Product / Process Change Notification (PCN)

PCN #: PCN_MPC3_20191010
Affected Series: WE-WR-MPC3
 6620xxx1822; 6620xxx13322
PCN Date: July 10, 2019
Effective Date: October 10, 2019

662 0xx 218 22

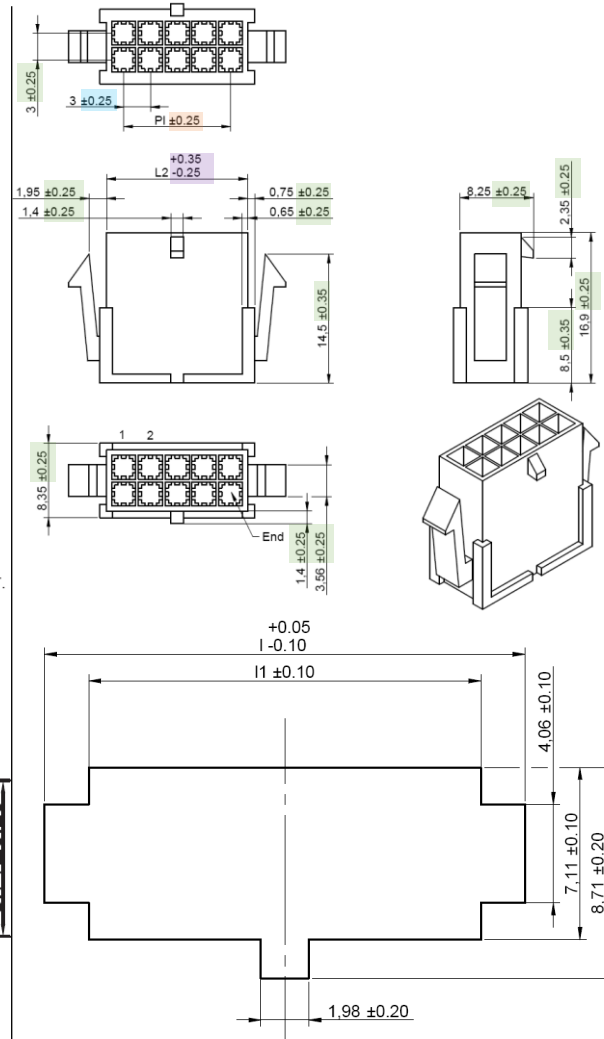
The plastic material will still be PA66. However the material behavior is slightly different during the production process and as Würth Elektronik will keep the current molds the parts tolerances dimensions will slightly change.

RECOMMENDED PANEL CUT-OUT
RECOMMENDED THICKNESS: 1.4–2.54mm

Panel Cut - Thickness: 1.4 - 2.54mm

662 0xx 118 22

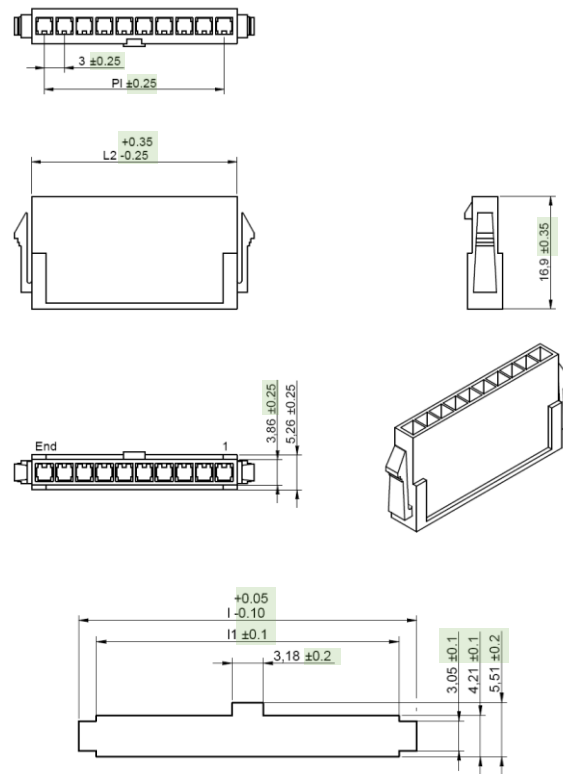
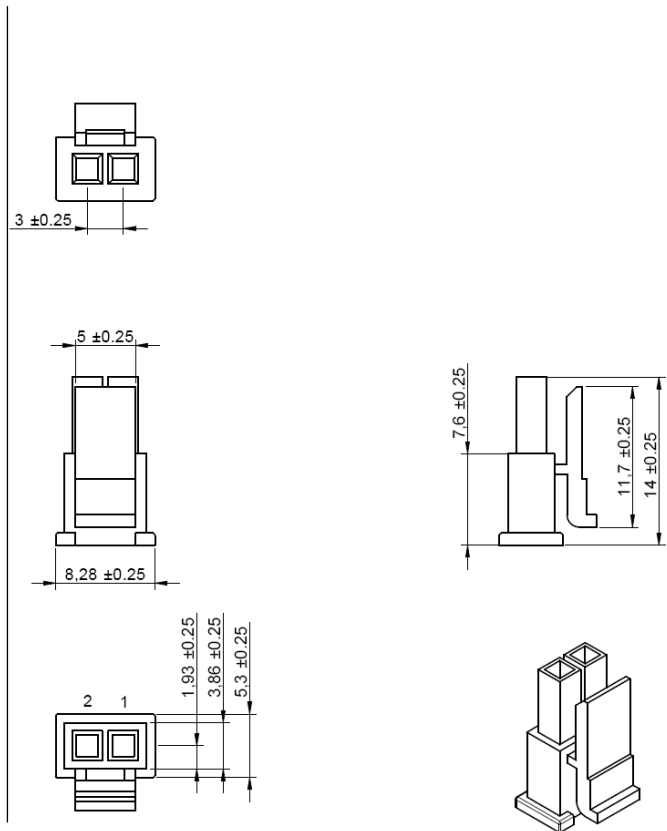
Recommended Panel Cut-out Thickness = 1,95 ±0,25

Panel Cut - Thickness: 1,4 - 2,54mm

662 002 013 322

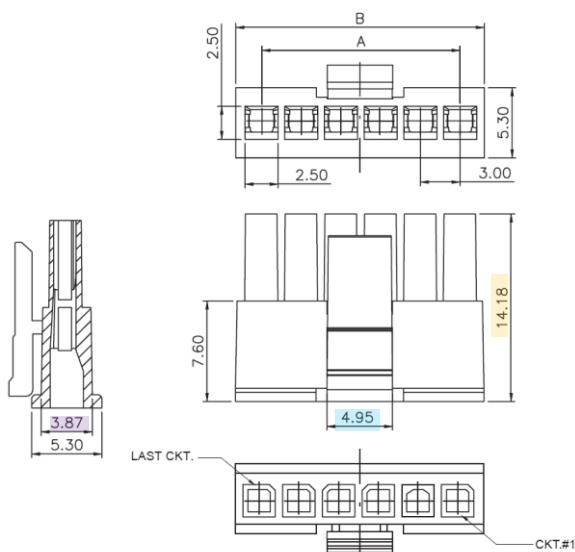
The specific datasheet for polarity 2 was missing but the design was the same
